STAFF REPORT
(Final Plat; Preliminary Approved 3/24/88)

CASE NUMBER: S/D 88-12 - BALL ADDITION

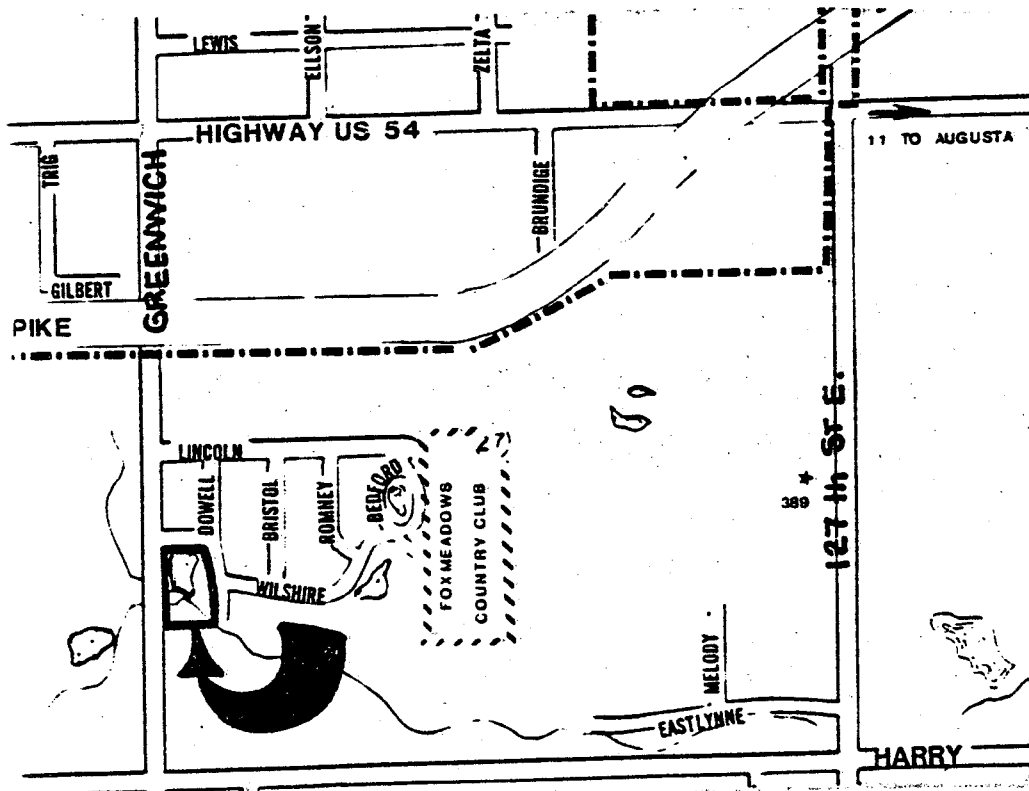
- A. The applicant shall guarantee the extension of sanitary sewer to serve the lots being platted.
- B. The applicant shall guarantee any drainage improvements required by the platting of this property.

- D. Since this property will utilize a City of Wichita water supply line in Greenwich Road, the applicant shall submit an outside-the-City water service application and associated restrictive covenant.

- E. Provisions shall be made for ownership and maintenance of the proposed reserve. The applicant shall either form a lot owners' association prior to recording the plat or shall submit a covenant stating when the association will be formed, when the reserve will be deeded to the association and who is to own and maintain the reserve prior to the association taking over those responsibilities.

- F. In order to provide Lot 5 with additional buildable area, the final plat tracing may include a note which states that a rear yard setback, from Reserve A, is not required on Lot 5.

- G. As required by the drainage plan for this property, the applicant shall submit, for recording, a restrictive covenant that prevents the development of Lots 4 and 5 until the spillway located at the southerly end of the existing lake is improved.

- H. On the final plat tracing, the amount of right-of-way being dedicated for the Dowell Street cul-de-sac shall be increased to a street/property line diameter of 100 feet. The right-of-way shall be offset.

- L. At the time of preliminary plat review, a requirement was made for the submitting of a sanitary sewer layout plan. The City Engineer's representative should be prepared to comment on the status of the applicant's sewer layout plan.

- M. Perimeter closure computations shall be submitted with the final plat tracing. Section 5-101(C).
- N. The representative from the County Engineer's office should be prepared to comment on the status of the applicant's drainage plan.
